ADDENDUM NO. 3

Issue Date: February 13, 2023

Project Name: Replacement Pontoon Boat Dock at the Environmental Learning Center

Bid Number: 2023021

Shore Perpendicular Typical Cross-Section

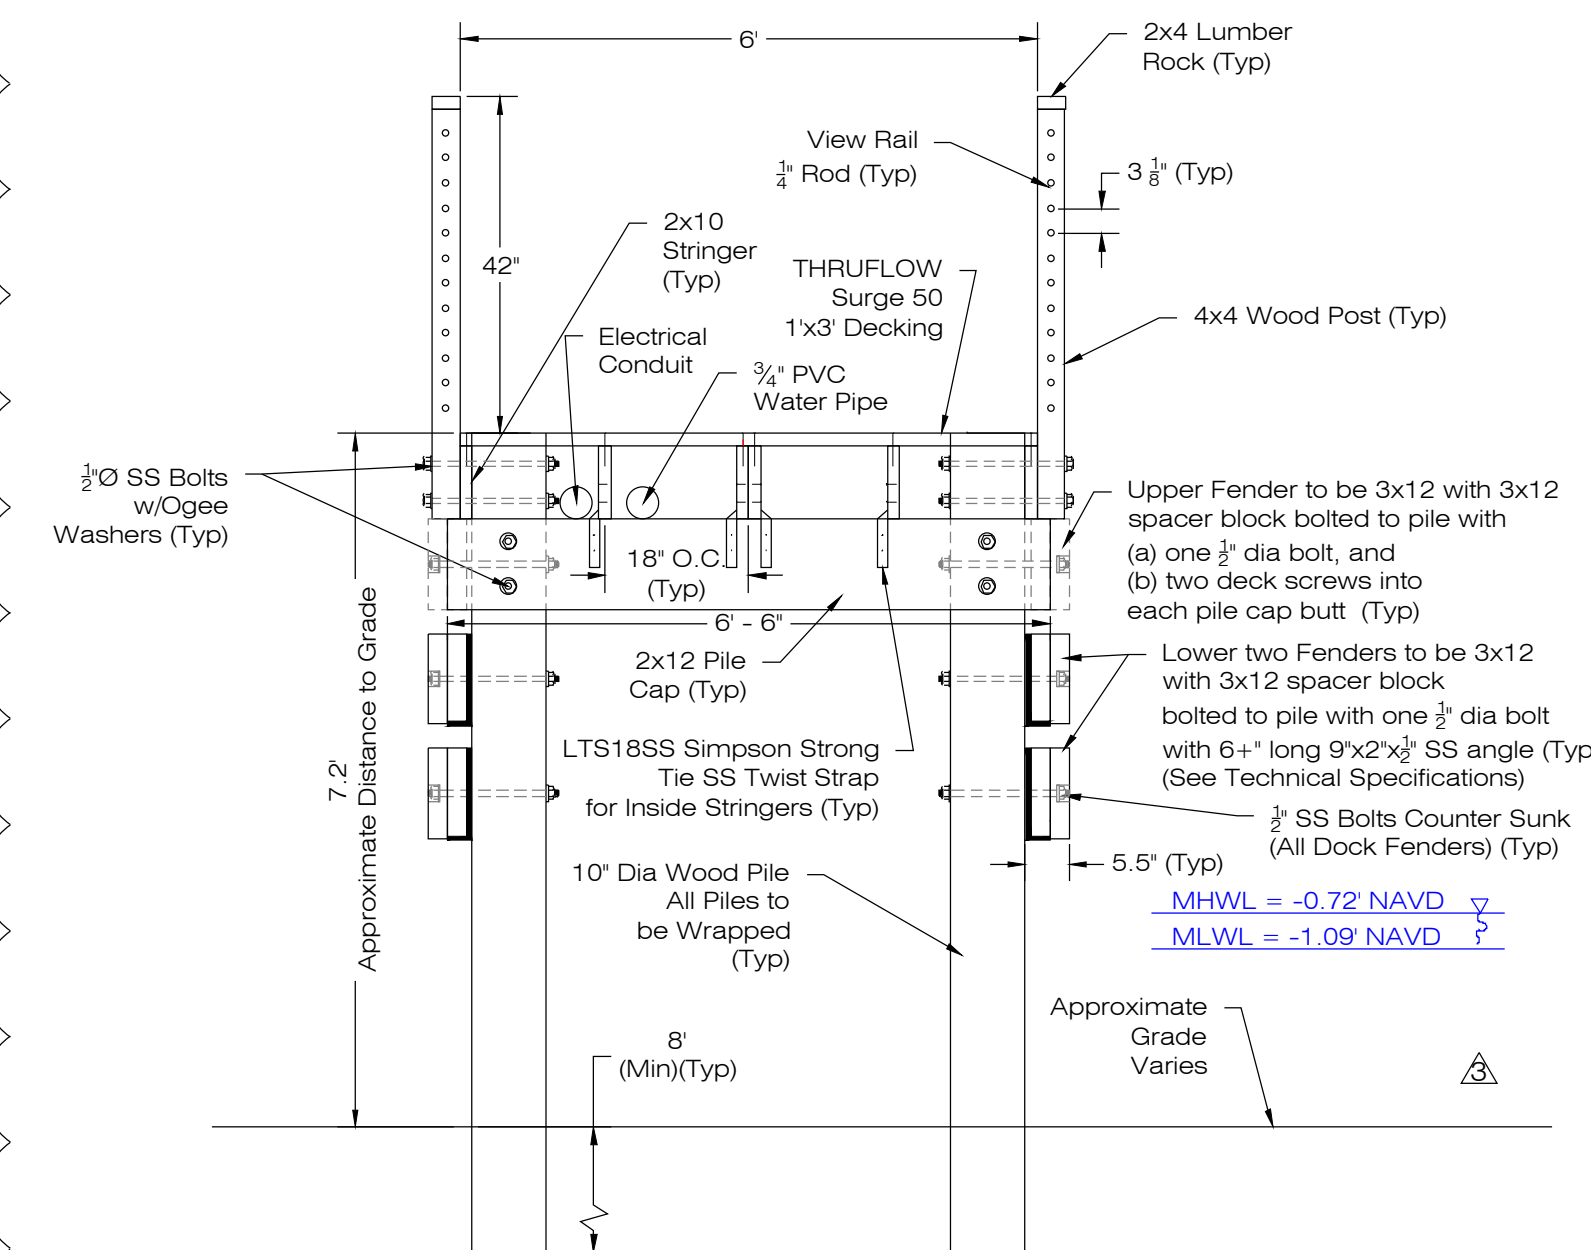
Rev.	Date	Notes
1	2025-01-20	Notes sheet and dock fender details
2	2025-05-02	Revised Typical Details
3	2025-05-10	Revised Shore Perpendicular Typical Cross-Section
